TENNESSEE VALLEY AUTHORITY

KINGSTON FOSSIL PLANT

ANNUAL ASH POND DIKE
STABILITY INSPECTION
2008

Prepared by: Jamey Dotson
Date: February 15, 2008

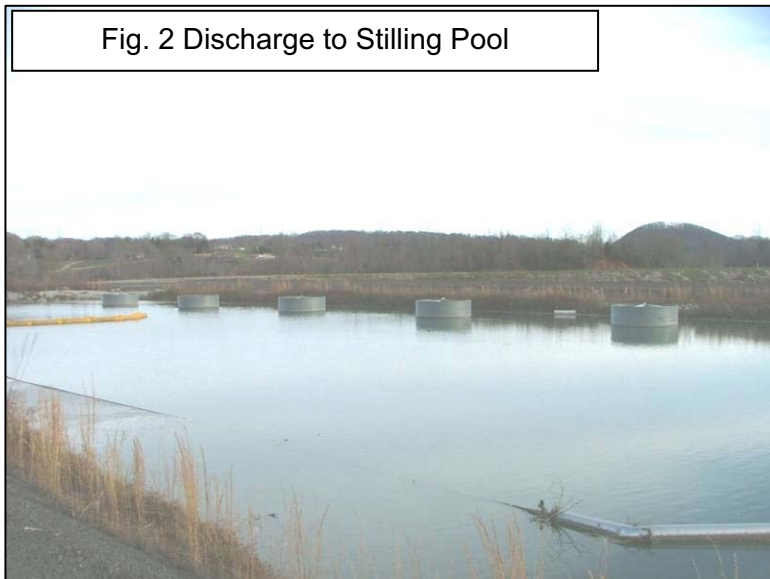
Fly ash is sluiced into an adjacent channel to the bottom ash channel where it flows into the main ash pond. The fly ash channel was cleared of vegetation last year. Both channels flow northeast into the active ash pond. See Figure 1 and drawing API 2008.

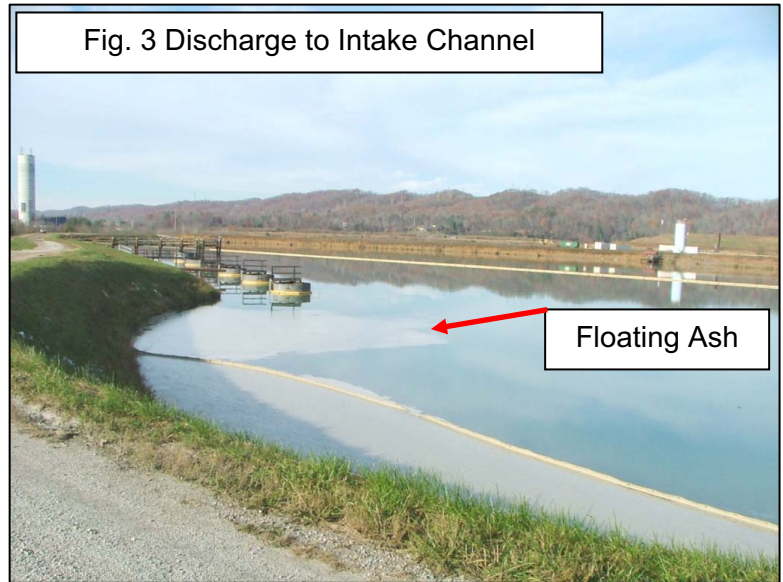
Sluice water flows from the active ash pond into the stilling pond through the five spillways constructed in 2005 (see Figure 2), as part of a project to allow more accurate accounting of free water volume. The old plant constructed spillway (Kennedy Weir) was taken out of operation at the same time. From the stilling pool, the water discharges into the plant intake channel via six standard spillways equipped with discharge diffusers constructed in November 2003. Many of these structures have vegetation and brush growing inside them, which needs to be removed.

All exterior dike slopes around this area appeared to be in sound condition with excellent vegetative cover. The interior of Dike "C" is showing some signs of erosion at the water line. These areas should be stabilized with riprap to prevent wave action erosion. The dikes had been mowed recently and were in very good condition. The grass on the dike between the stilling pool and the intake channel was only cut halfway down the slope leaving a vegetative buffer zone. Previously, grass clippings from mowing this slope had entered the discharge spillways partially clogging them. This caused the stilling pond level to raise a couple of inches. Plant personnel inquired about spraying this

- Remove vegetation growing inside spillway structures.
- Investigate the use of spraying to inhibit vegetation growth on the interior dikes of the stilling pond.

Fig. 10 Trees near Discharge to Pond

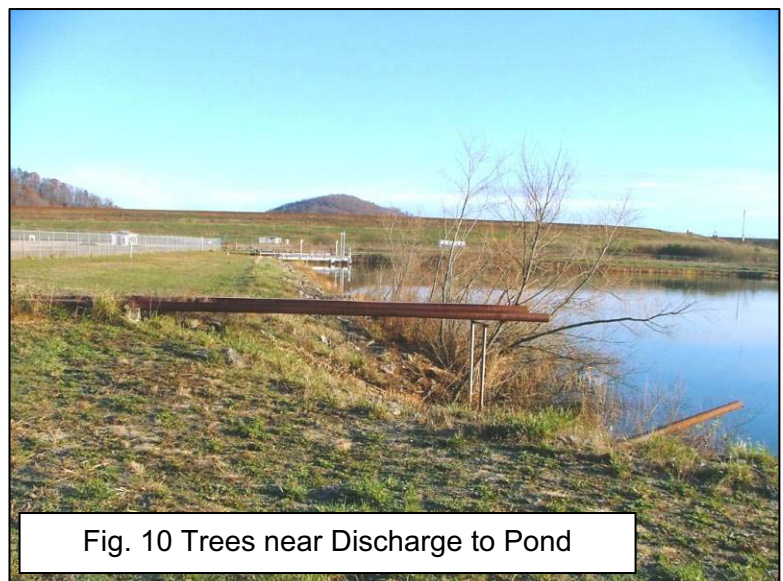
The chemical treatment ponds (iron and copper) are located southwest of the active ash pond. Both ponds were excavated and have no exterior slopes. The internal dike slopes are covered with riprap. These slopes were in good condition with a few trees present. See Figure 10. Sediment in the ponds was tested in FY 2004 and found to be non-hazardous. It appeared that some maintenance had been recently performed at one of the pond platforms. Old gaskets were on the ground and there was a new pipe flange and hardware. The platform at the smaller pond was missing a pump.

- Remove trees from the slopes of the dikes. Mowing at least twice a year is recommended to control the size of the trees. Preventing the trees from getting larger than 1" in diameter at the ground is preferred. Any trees larger than 3" in diameter at the base must be pulled from the dikes, roots and all. Repair and reseed the damaged area.

Fig. 12 Engineered Wetlands

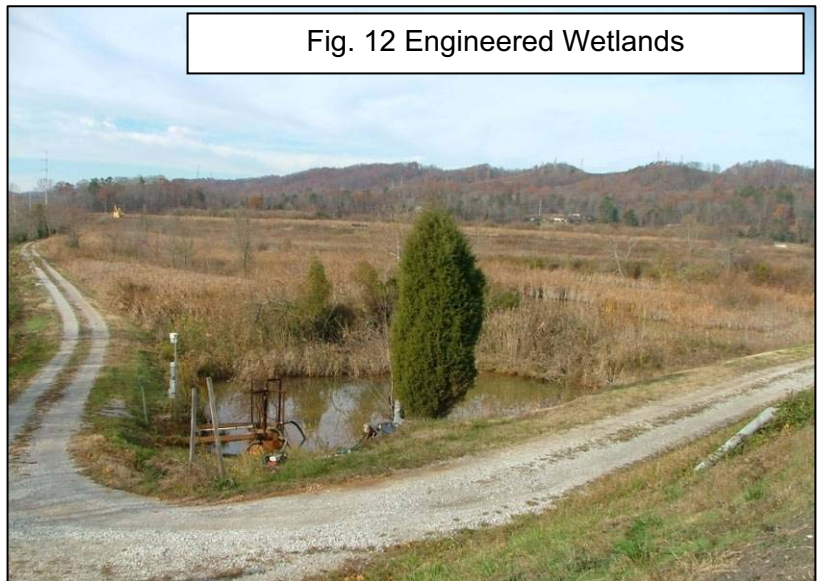
The engineered wetlands along the southwest dike receive seepage that collects in the anoxic limestone drain below the bottom ash trench. The wetland appeared to be functioning, but the discharge is still pumped via two pumps to the ash pond, see Figure 12.

The water levels in the pump structures were at different levels at the time of inspection. There were several trees varying in size growing on the interior dikes of the ponds.
